RFI

Information Requested: Asphalt Limits

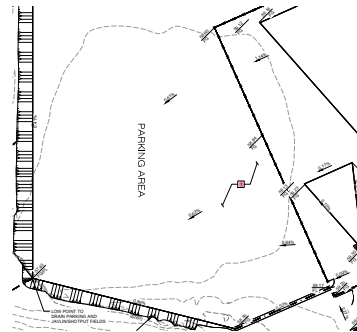
Description: 1) Drawing G1, Note 1 is labeled for 2" Asphalt
What will be the asphalt paving limits for this parking area?

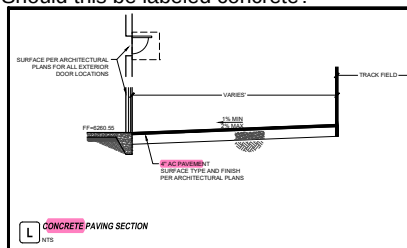
2) Drawing GD, Detail L might have a discrepancy. Should this be labeled concrete? _____
